<b>Project</b>	<b>IEEE 802.16 Broadband Wireless Access Working Group</b> < <a href="http://ieee802.org/16">http://ieee802.org/16</a> >	
<b>Title</b>	<b>Using the Relative Thresholds in Handover Procedure</b>	
<b>Date Submitted</b>	<b>2006-01-08</b>	
Source(s)	Ardian Ulvan Zdenek Becvar Jan Zelenka Robert Bestak Czech Technical University in Prague Technicka 2 166 27, Prague 6 Czech Republic	Voice: +420 2 2435 5994 Fax : +420 2 3333 9810 <a href="mailto:becvaz1@fel.cvut.cz">mailto: becvaz1@fel.cvut.cz</a>
Re:	Call for Technical Proposals regarding IEEE Project 802.16j 2006-12-12	
Abstract	This contribution proposes the changes in the diversity set and anchor BS updating procedure.	
Purpose	This contribution is provided as input for the IEEE 802.16j amendment	
Notice	This document has been prepared to assist IEEE 802.16. It is offered as a basis for discussion and is not binding on the contributing individual(s) or organization(s). The material in this document is subject to change in form and content after further study. The contributor(s) reserve(s) the right to add, amend or withdraw material contained herein.

# Using the Relative Thresholds in Handover Procedure

Figure 2. Diversity set updating procedure with relative thresholds

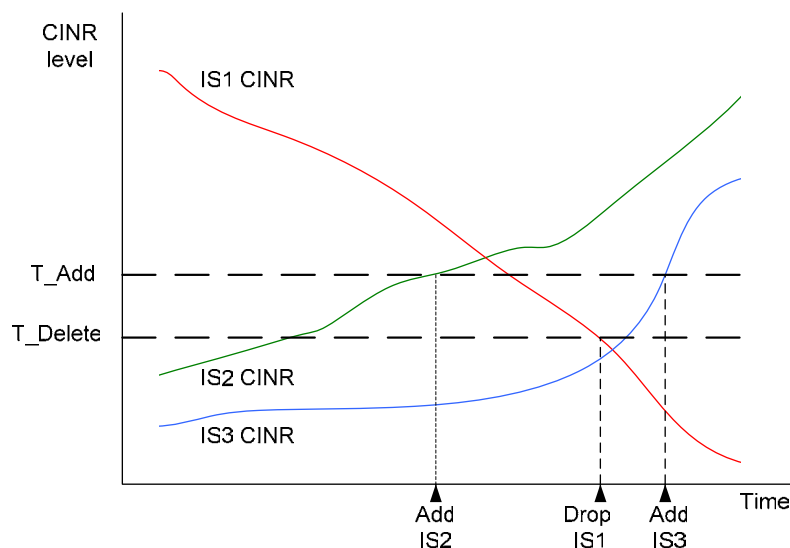
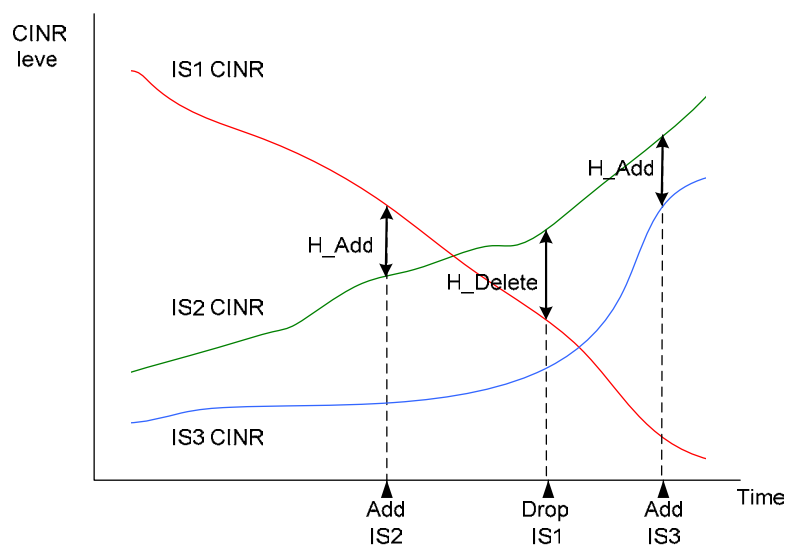
The threshold values are set in the fields H\_Add Threshold and H\_Delete Threshold in DCD message. In [1], H\_Add Threshold and H\_Delete Threshold are absolute values and are used by MS to add and drop a neighbour IS to the diversity set respectively. For these absolute thresholds the diversity set is updated every time when the measured CINR mean is higher or lower than H\_Add or H\_Delete thresholds. This situation is illustrated in the figure 1.

The proposed modification is to use the relative thresholds instead of absolute one. It means the diversity set updating is based on the interrelation among the CINR means of the involved ISs. The MS should send a request to add this neighbour IS to the diversity set when the difference between neighbour IS CINR and serving IS CINR is less than  $H\_Add$  Threshold. The MS should send a request to drop the IS from the diversity set when the difference between this IS CINR and serving IS CINR is greater than  $H\_Delete$  Threshold.

Absolute threshold are easier to implement, but it has difficulty in dealing with dynamic load changes. The using of the relative thresholds allows the reducing of the length of threshold parameters from 8 bits to 4 bits per parameter because the relative threshold values are in the lower order than absolute. In the proposal the parameters were integrated into one parameter with two parts per 4 bits as it can be seen in Table 358.

The IS supporting MDHO shall broadcast the DCD message that includes the  $H\_Add$  Threshold and  $H\_Delete$  Threshold. These thresholds, the CINR mean of neighbour IS and IS that are in the current diversity set are used by MDHO handovers to decide if MOB\_MSHO-REQ should be sent. The MS should send MOB\_MSHO-REQ asking to add this neighbour IS to the diversity set when the difference between neighbour IS CINR and serving IS CINR is less than  $H\_Add$  Threshold. The MS should send MOB\_MSHO-REQ asking to drop the IS from the diversity set when the difference between this IS CINR and serving IS CINR is greater than  $H\_Delete$  Threshold.
